Name Of Dam: WESTERN BRANCH RESERVOIR
Location: CITY OF SUFFOLK
Inventory Number: VA. 12311

PHASE I INSPECTION REPORT

WESTERN BRANCH RESERVOIR DAM
CITY OF SUFFOLK, VIRGINIA
(Formerly Nansemond County)
INVENTORY NO. VA 12311

Deward M. Martin & Associates, Inc.
August 1979

SECTION C-C
TYPICAL SECTION OF RETAINING WALL

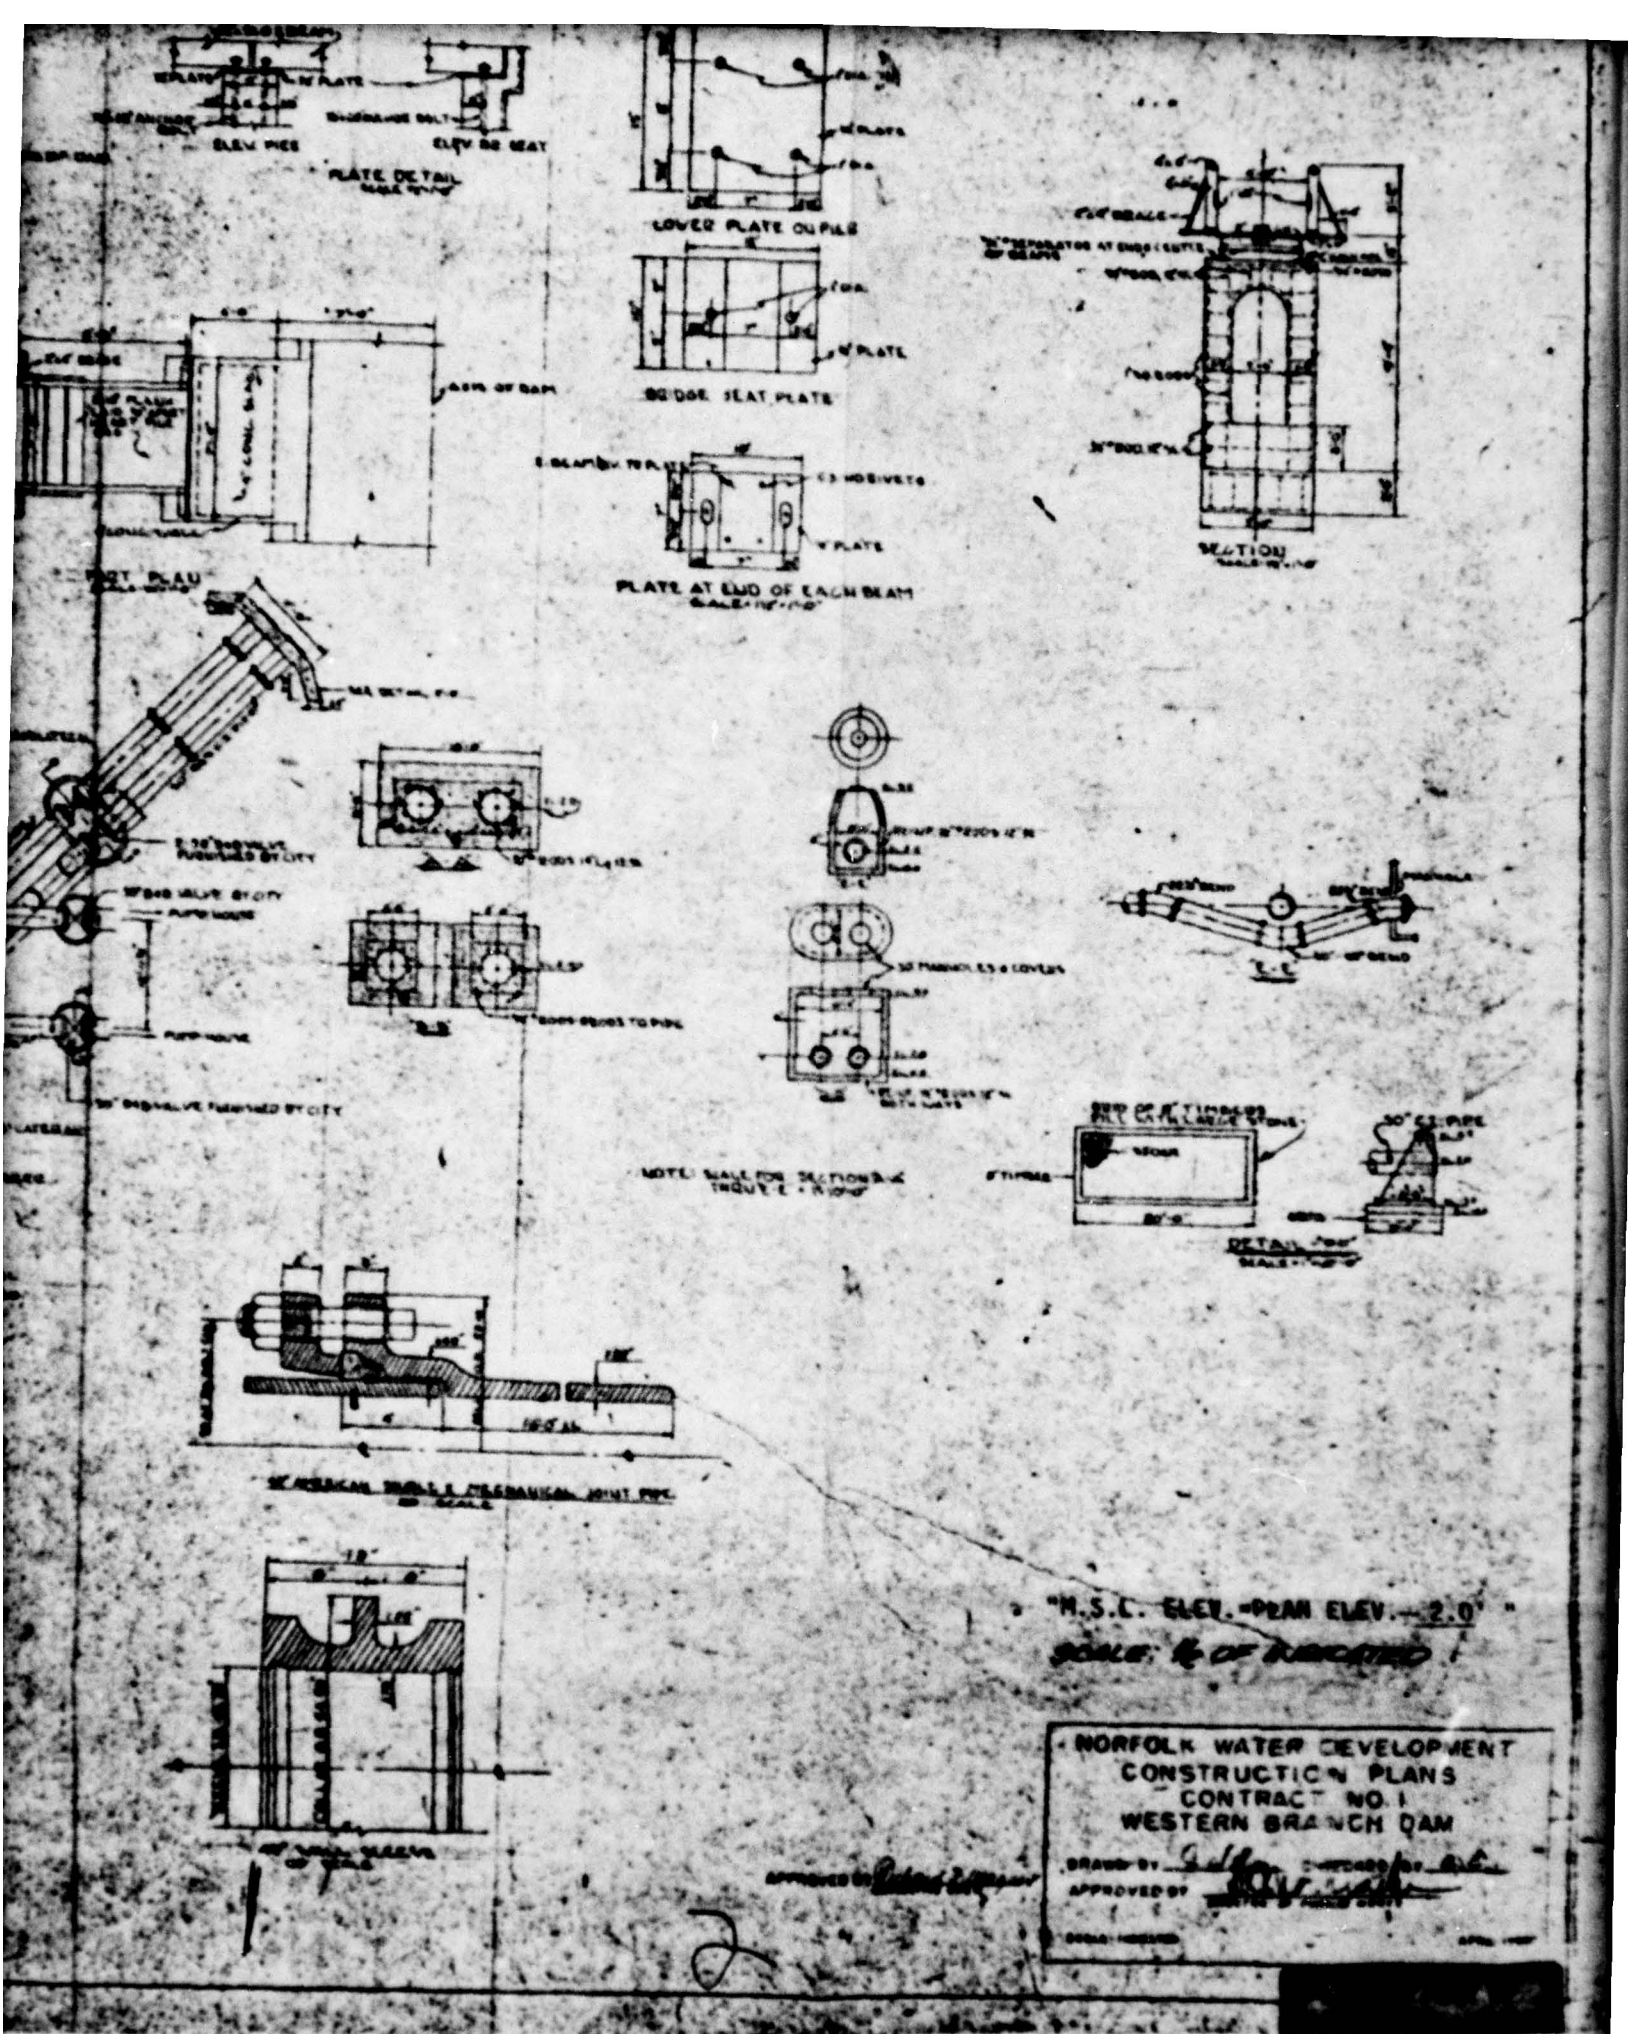
The pondered water located at the toe of the embankment could cause the soil to become soft and muddy unless the drainage conditions are corrected. The settlement in the parapet wall appears to have occurred some time ago and does not show signs of recent movements or major structural damage. Settlement and tilting detected in one section of the spillway wall may, if movement is still continuing, indicate potential failure of that section of the wall.

- a. The ponded water should be removed from along the downstream toe of the dam and steps should be taken to insure that surface water drains away from the toe of the dam to the nearby ditch.
- b. The owner should monitor the settlement of the parapet wall and if settlement continues, remedial measures may be required to protect the integrity of the dam.
- c. An annual maintenance and inspection program should be initiated to help detect and control problems that may occur.
